DOUGLAS COUNTY
COLORADO

Minor Development Final Plat Staff Report

Date:	September 9, 2025
To:	Douglas County Planning Commission
From:	Carolyn Washee-Freeland, AICP, Senior Planner CWF Jeanette Bare, AICP, Planning Manager JB Steven E. Koster, AICP, Assistant Director of Planning Services SK
Subject:	**Antelope Crossing – Minor Development Final Plat**
Project File:	**SB2024-066**

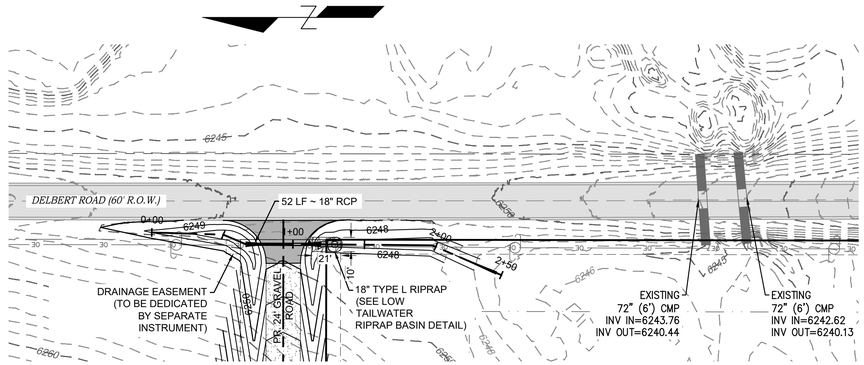
a headwall will be required for the dual pipes

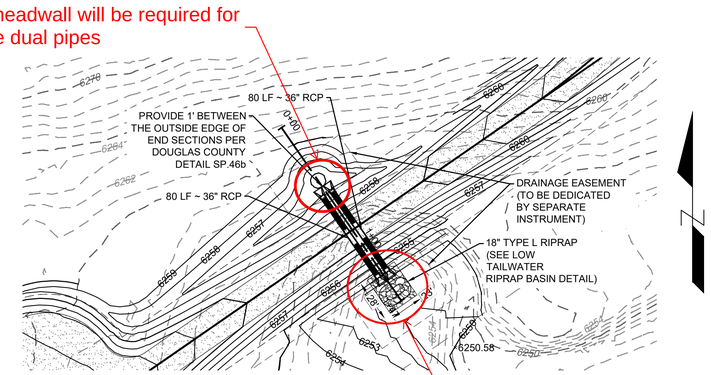
the size of the low tailwater basin will need to be based on a 60-in. culvert
